Accessibility Survey

City of Downey Florence Avenue & Woodruff Avenue

Date of Inspection
2/2/2017

Disability Access Consultants

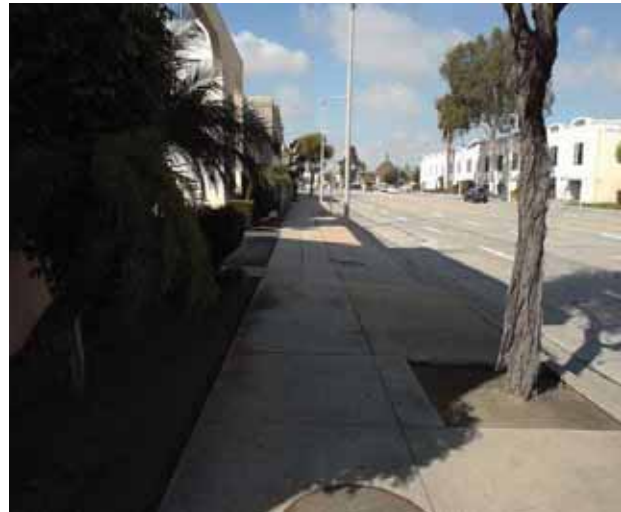
Sidewalk cross slope is not compliant.

On-Site Finding 3.60 percent for 80.00 feet

Repave the sidewalk surface with the recommended cross slope.

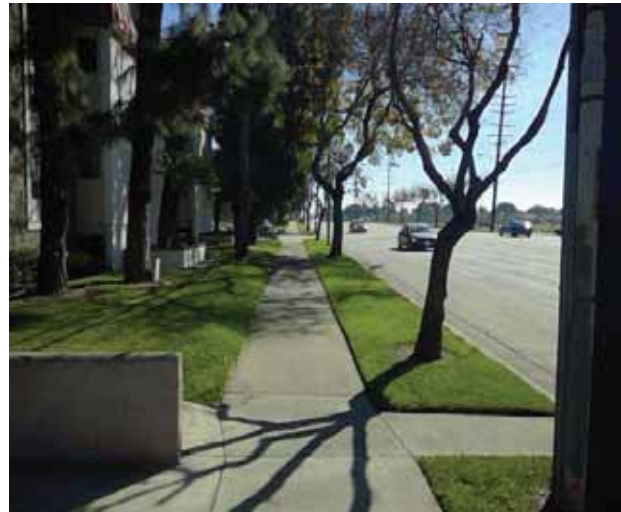
There is a change in elevation greater than recommended value.

On-Site Finding 0.62 inches

Ensure that the change in elevation is within the recommended value.

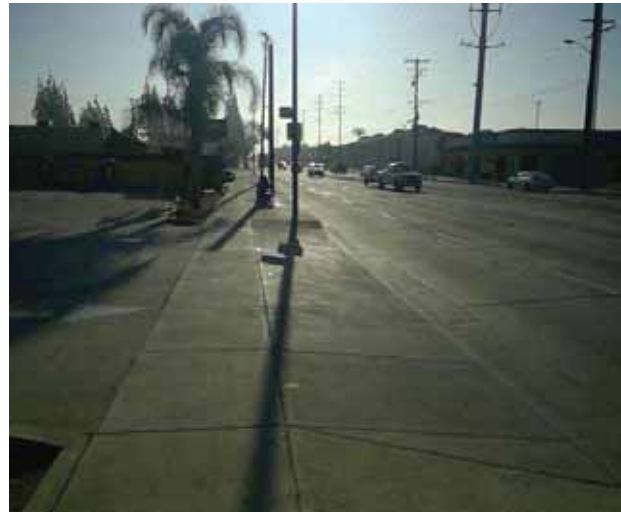
There are no detectable warnings where the pedestrian route crosses vehicular traffic.

On-Site Finding Not Found

Provide detectable warnings.

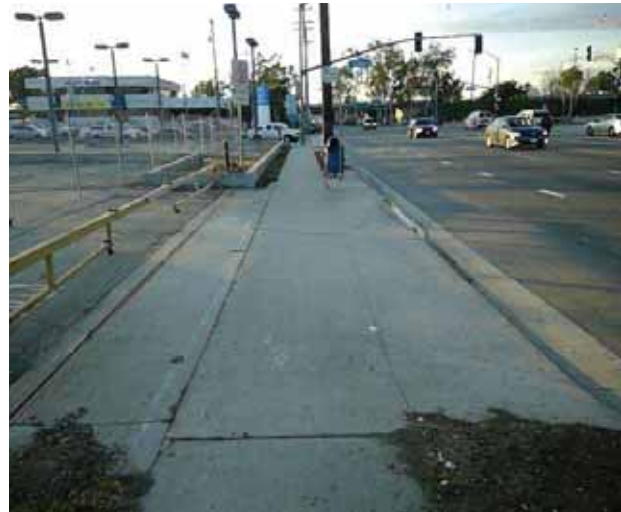
There are no detectable warnings where the pedestrian route crosses vehicular traffic.

On-Site Finding Not Found

Provide detectable warnings.

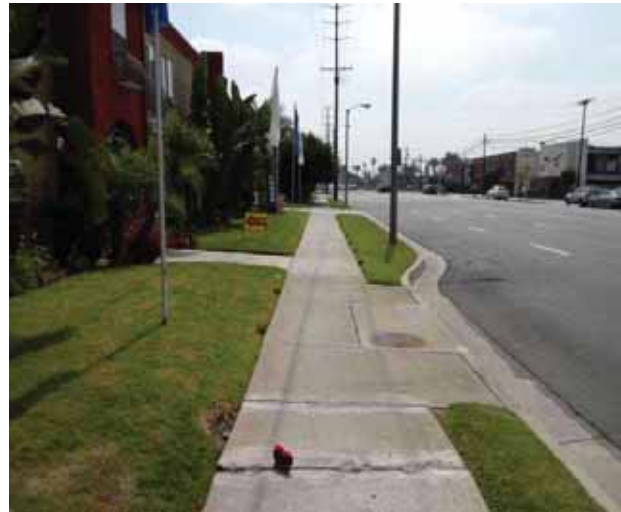
There is a change in elevation greater than recommended value.

On-Site Finding 0.50 inches

Ensure that the change in elevation is within the recommended value.

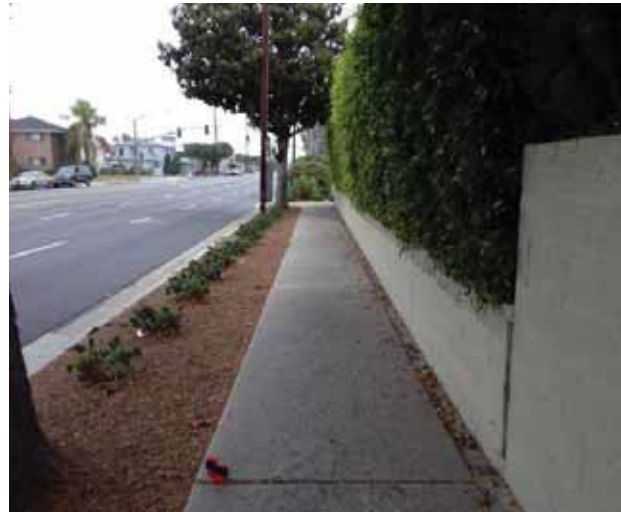
There is a change in elevation greater than recommended value.

On-Site Finding 0.37 inches

Ensure that the change in elevation is within the recommended value.

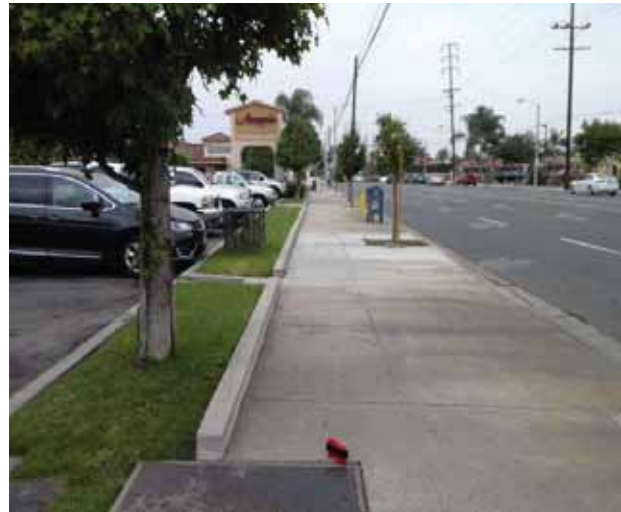
There is a change in elevation greater than recommended value.

On-Site Finding 0.62 inches

Ensure that the change in elevation is within the recommended value.

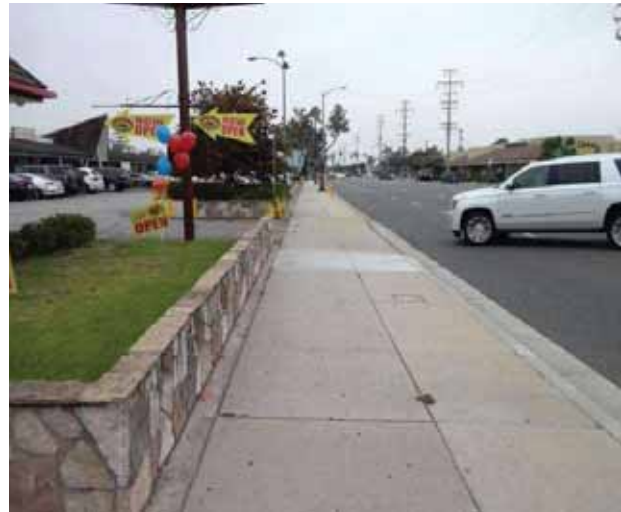
Ground surface has an opening that is not compliant.

On-Site Finding Not Compliant

Make sure that the surface opening does not allow passage of a sphere more than 1/2 inch in diameter.

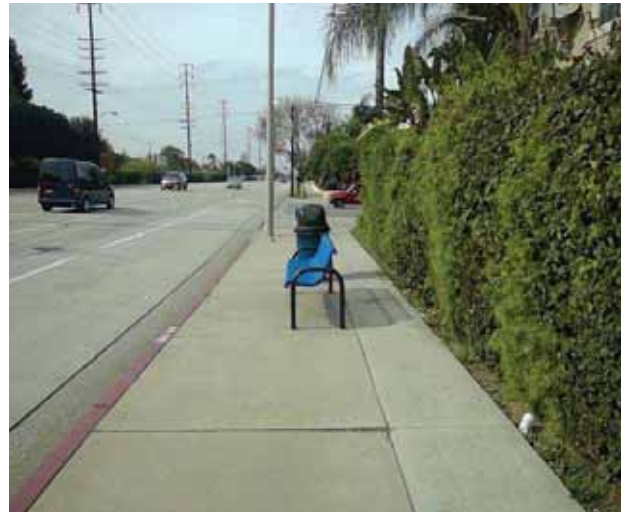
There is a change in elevation greater than recommended value.

On-Site Finding 0.75 inches

Ensure that the change in elevation is within the recommended value.
